ABLOOM DESIGN LIMITED (Extension)

37, South Shastapur, Upazila Road, Fatullah, Narayanganj
(23.637976, 90.491952)
26 December 2022

Observations

Core test report

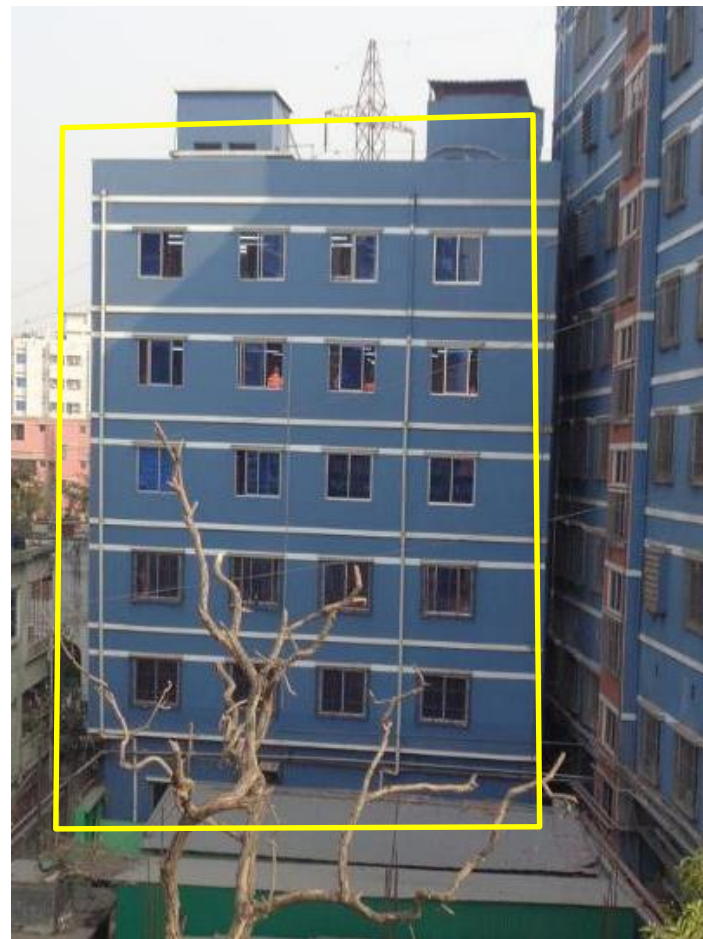
Concrete core test reports were available on factory site but design report was not prepared yet. The building engineer is required to produce design report based on equivalent material strength of concrete cores following BNBC.

Discontinuity of RC column at stair landing portion

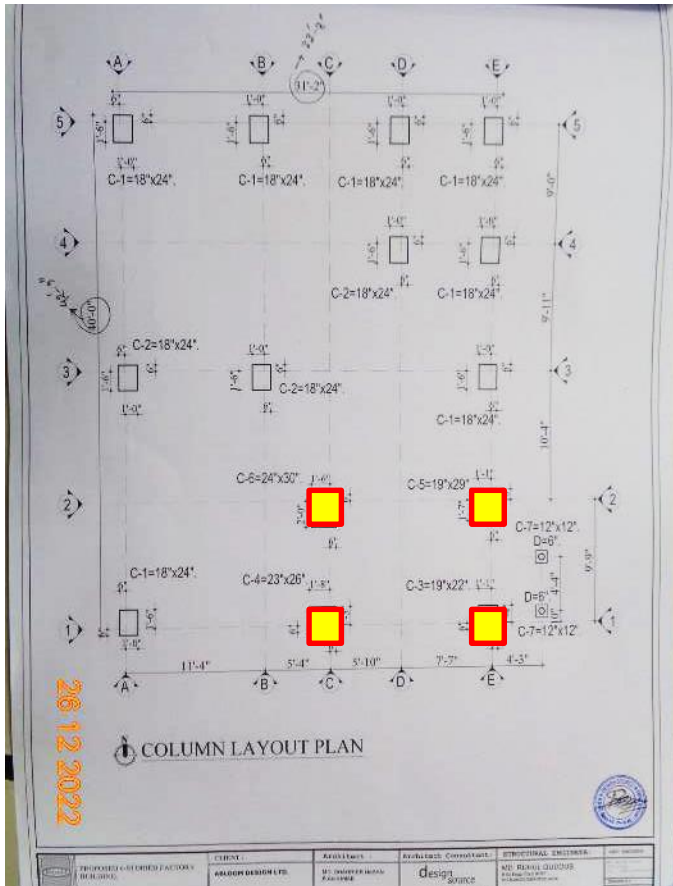
The factory constructed 4 RC columns around the existing steel stair columns. But in the joint of stair landing beam and column, RC casting has not done which makes the column discontinue and non-uniform through its length. The building engineer is required to investigate the beam-column joint and suggest necessary remedial actions.
